**IN RESPONSE TO THE OFFICE ACTION:**

Serial No.: 10/709,483  
Confirmation No.: 1684  
Applicants: KINGSTON, Timothy *et al.*  
Atty. Ref.: 7589.165.PCUS00

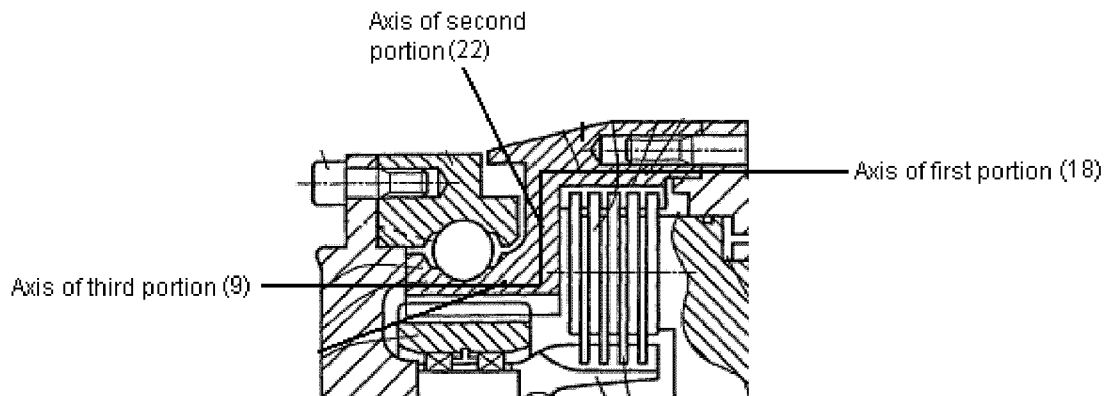
According to the Office Action, the specification is objected to as failing to provide proper antecedent basis for the subject matter recited in claim 1 as follows, "the second portion having an orthogonal relationship to the first portion and the third portion."

Paragraph [0039] has been amended to provide written antecedent basis in the specification by providing description of the positional relationships of the first portion, the second portion and the third portion as originally shown in Figure 1 and Figure 2 of the application. A portion of Figure 1, reproduced below, provides evidence showing the axes of the first, second and third portions, and that the second portion has an orthogonal relationship; i.e., is at right angles to the other two portions.

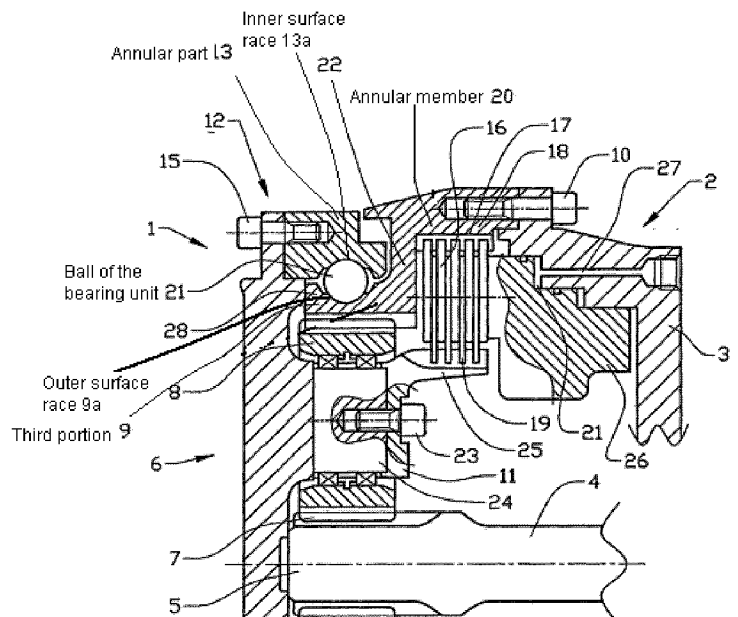
Recitation of claim 1 that, “at least one race formed therein for alignment with at least an opposing race in an inner face of an annular part overlapping at least a portion of the outer surface to provide a bearing unit comprising the outer surface and the annular part to retain balls between the at least one race and the at least an opposing race” was considered unclear.

Paragraph [0042] has been amended to provide antecedent basis in the specification by providing description of the bearing unit that includes at least one race aligned with an opposing race. Further claim 1 has been amended to replace “at least an opposing race” with --an opposing race-- to indicate one race facing an opposing race. The intended relationship is clarified by numerals and labels in the following drawing that is a portion of Figure 1.

Comments in the Office Action relating to an “inner race” and “an outer race” have been interpreted to refer to “an outer surface having at least one race” and “an opposing race in an inner face.” Amendment of claim 1 to remove “at least” from the recitation of “an opposing race” is intended to clarify that one race aligns with an opposing race rather than suggest the presence of more opposing races.
